SERVICE BULLETIN

Communication #: T-20-01

Model Year(s): 2020

SUBJECT: OIL VOLUME & PCV FITTING

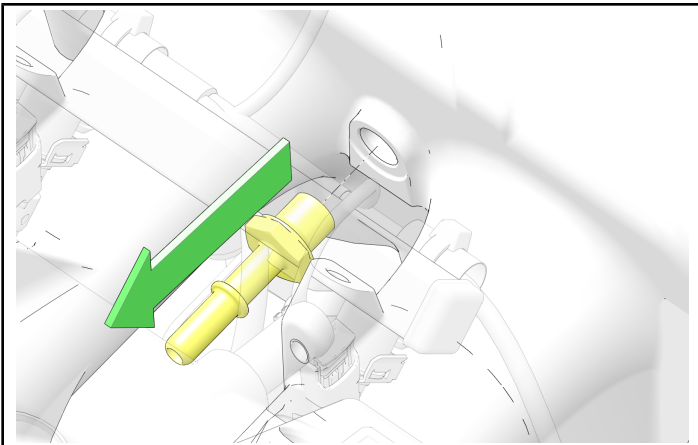
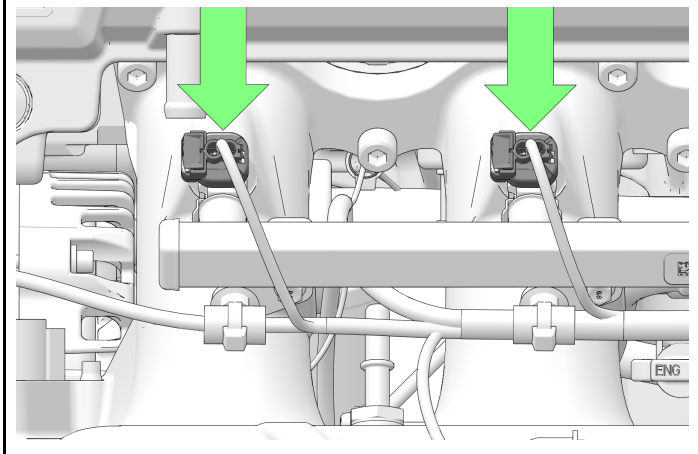
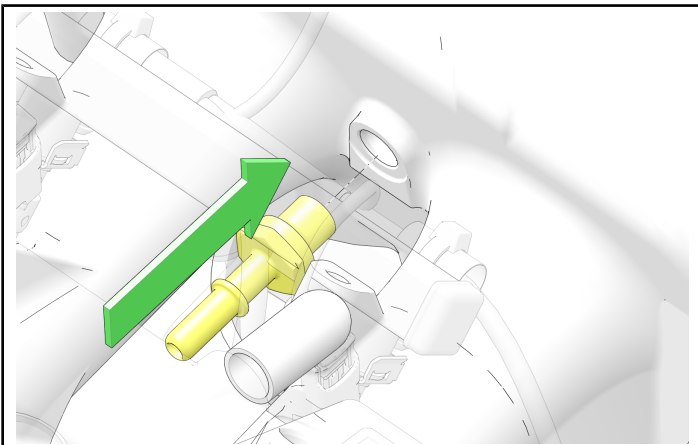
To resolve this concern, Polaris has developed a new PCV fitting with a decreased orifice size and increased the engine oil quantity from 5 to 6 quarts.

5. Using a 17 mm deep-well socket, remove the PCV fitting from the intake and discard.

6. Using a 18 mm deep-well socket, install the **NEW** PCV fitting. Torque to specification.

PCV Fitting:
106 in-lbs (12 N·m)
